Docket Item # 15
BAR CASE # 2007-0157

BAR Meeting
September 5, 2007

ISSUE: Demolition/encapsulation
APPLICANT: Mark & Ann Kington by Belinda Reeder
LOCATION: 617/619 South Lee Street
ZONE: RM/Residential

Figure 4 - East elevation

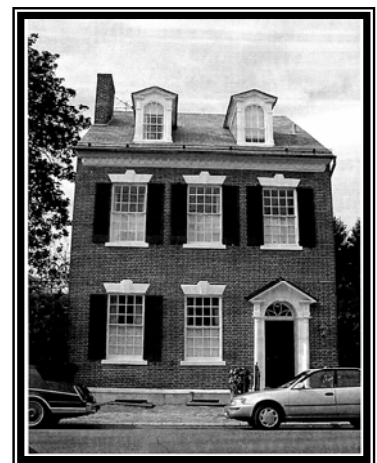
According to the HABS report, “the late Federal town house [is] designed in the indigenous manner with particular attention to proportions and refinements of detail” (page 5). The property has fairly high degree of integrity, perhaps due to the fact that it has had relatively few owners. The alterations, mostly confined to the wings, were each relatively minor but had a cumulative effect. The integrity of the house is enhanced by its setting. It has extensive grounds that extend through the block to South Fairfax Street and include a pool, gardens, tennis courts and a carriage house.
